{In Archive} Fw: Responses to EPA Risk Assessment Comments on West  
Lake Landfill SFS

From: "Paul Rosasco" <paulrosasco@emsidenver.com>  
To: Dan Gravatt/R7/USEPA/US@EPA  
Cc: Rich Kapuscinski/DC/USEPA/US@EPA, <shawn.muenks@dnr.mo.gov>  
Date: 04/27/2011 11:52 AM  
Subject: RE: Responses to EPA Risk Assessment Comments

## **EPA Appendix F - Risk Assessment # 20**

**Figure 7-1 Stylized Cross-Section of the On-site Cell "**

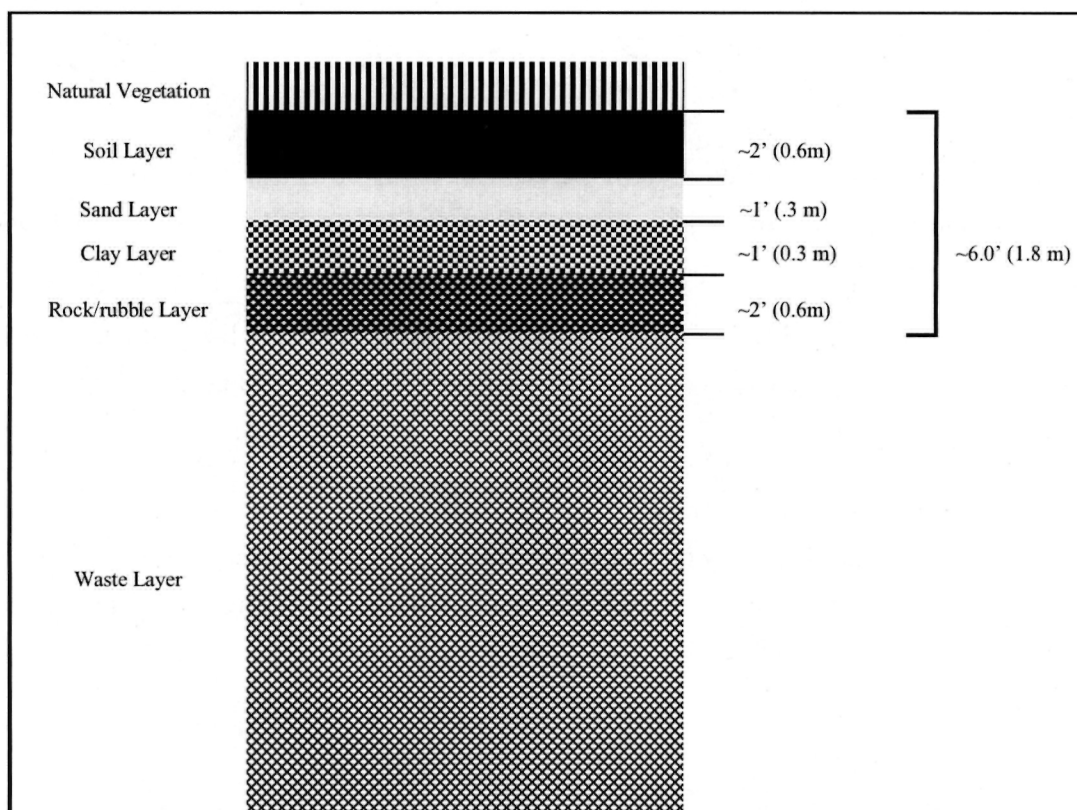
Section 7.2.1: The physical configuration of the on-site cell cap in this section does not exactly match the configuration in the text and on Figure 15, in that the geomembrane is not included here.

In addition, the proposed sand layer represents a plane of weakness which could compromise the cap's integrity over the design life of the cap. Once the cap configuration is agreed upon, this risk assessment may need to be revised.

The geomembrane was intentionally excluded from Figure 7-1. The effectiveness of the synthetic geomembrane over the 1,000 years was uncertain and only natural components of the cover design were included in the evaluation. The text has been changed to include the rationale for the geomembrane's exclusion.

Figure 7-1 depicts a stylized cross-section of the on-site engineered disposal cell's cover. A geomembrane is included in the engineered cover design, but it is not reproduced in this conceptual cross-section. The longevity of this membrane is uncertain and the membrane was not considered during the calculation of long-term risks. The conceptual models of the RIM below cleanup levels in Areas 1 and 2 after removal of RIM are identical to those presented in Section 6.2.1.

**Figure 5-1 Stylized Cross-Section of Area 1 after the ROD-Selected Remedy**

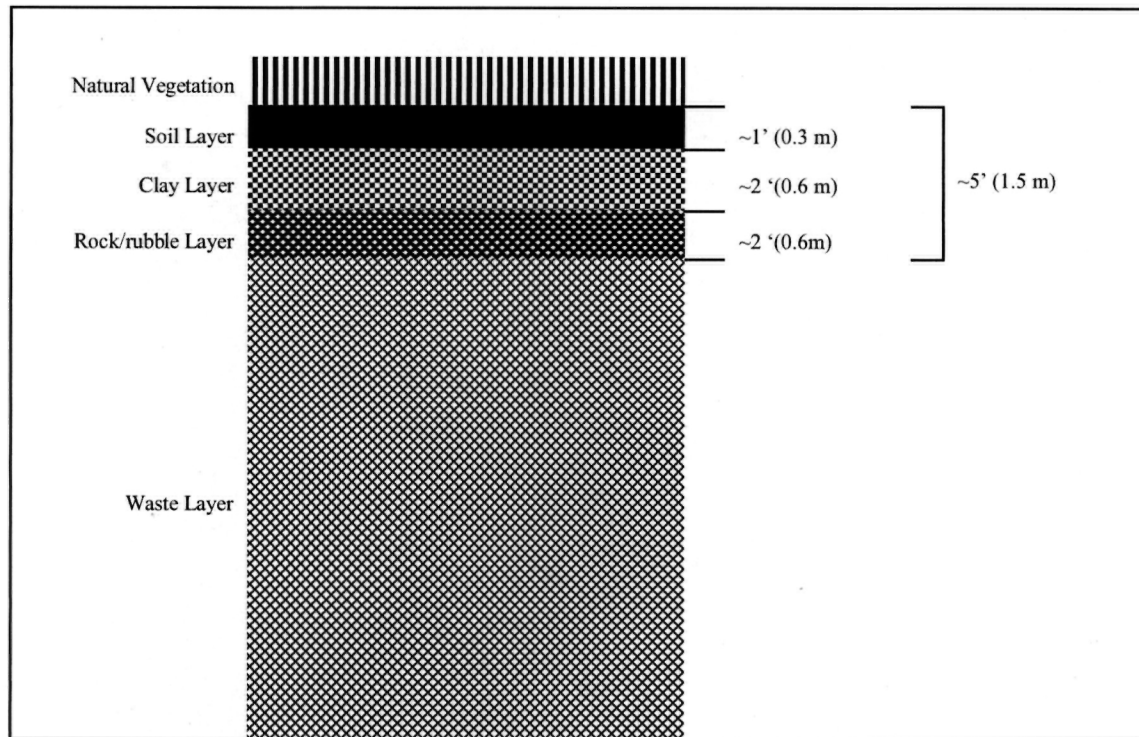
Section 5.3.1, third bullet: The "rock and clay layer" described here appears to be referred to as the "biointrusion layer" in Figure 5-1. These names should be made consistent. This inconsistency also occurs in Section 7.2.1 and Figure 7-1.

Agreed. All cross-sections in the risk assessment and the corresponding text have been revised.

Figure 5-1 depicts the cap design for Areas 1 and 2.

**Figure 6-1 Stylized Cross-Section after RIM Has Been Excavated  
and Sent for Off-site Disposal "**

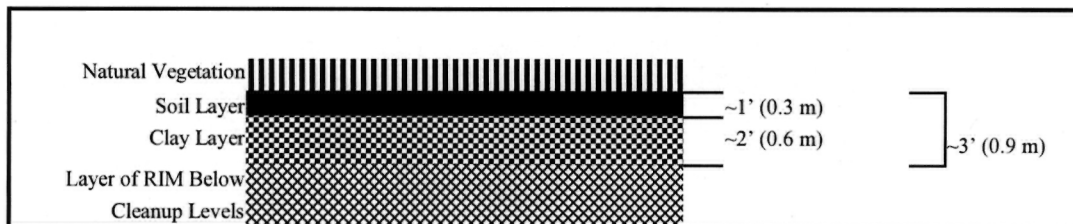
Section 6.2.1, third bullet: The rock layer described in this bullet is missing from Figure 6-1. The text and figure must be reconciled.

The text was has been changed to match the figure.

The text in Section 6.2.1 and Figure 6-1 has been reconciled and now reads:
